# Rezoning Transportation Analysis

Petition Number: 2019-028

General Location Identifier: 11106301, 11106398

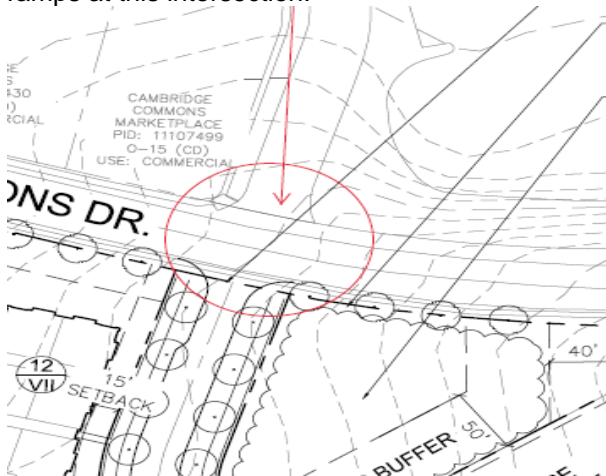
1. **Traffic Study** A Traffic Impact Study is necessary for the complete review of this petition. The traffic study will determine if the adjacent roundabout should open lanes for additional capacity, and other improvements.
2. ~~The petitioner should revise the site plan and conditional note(s) to commit to an 8' planting strip and a 12' Multi-Use Path.~~
3. ~~The petitioner should revise the site plan and conditional note(s) to commit to installing a pedestrian refuge on Cambridge Commons Drive to connect to shopping center in the general area shown below.~~ **Comment Rescinded**
